## FAYETTEVILLE PUBLIC WORKS COMMISSION

#### Bid Addendum

**Bid Title :** Fayetteville PWC Walking Trail Phase 1

**Addendum Number:** 1

**1** SITE PLAN - WALKING TRAIL  
CE1.2 1" = 50'-0"

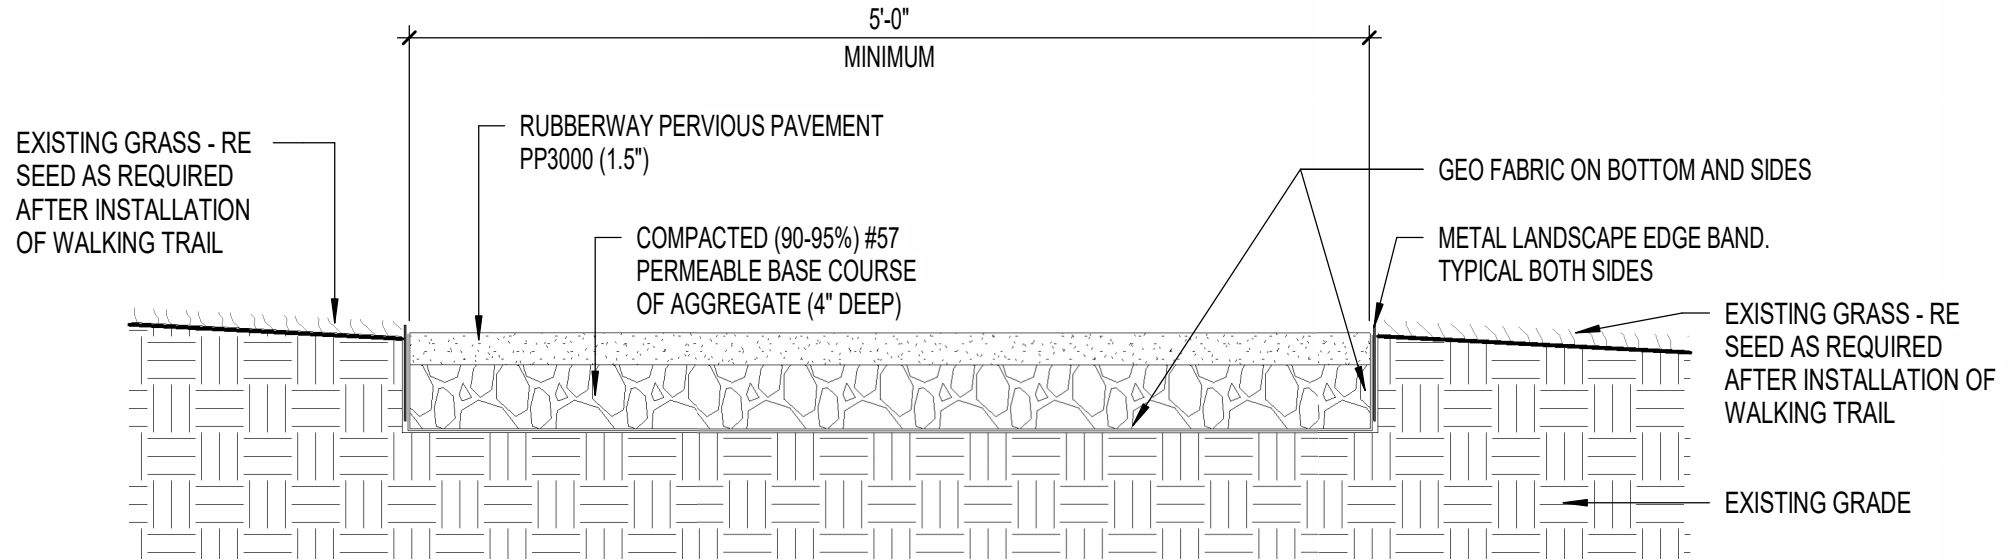
2. Following are questions received about the solicitation and the SME's answers to the questions.
    - Q1.** Are only the crosswalks that are denoted with a number 2 within a circle to be painted? There are some crosswalks on the plans that do not have this notation, and we would need some clarity on this to provide PWC with the most cost-efficient pricing. (Site Plan Keynotes #2).

- Q3.** At the location noted on the attachment as Question 3, There is a row of shrubbery and also some trees that would hinder providing the required 5' wide walk path. Could PWC please provide some clarification on what is to be removed from this area to meet the path requirements?

- A1.** Crosswalks are only to be painted at the locations indicated with Keynote #2. However, there was one crosswalk that was not labeled on the drawings. Please see the attached drawing with comments addressing this area. PWC will be crack filling and stripping the asphalt in the entire south complex as part of another project and the existing cross walks will be re-stripped at that time.

- A3.** At this location, indicated on the attached drawing, if there is a conflict with the shrubbery the trail will be slightly shifted away from the shrubbery during the construction staking. There is a small amount of shrubbery hindering the access to the existing concrete sidewalk at this location that will be removed by PWC's landscape contractor prior to construction.
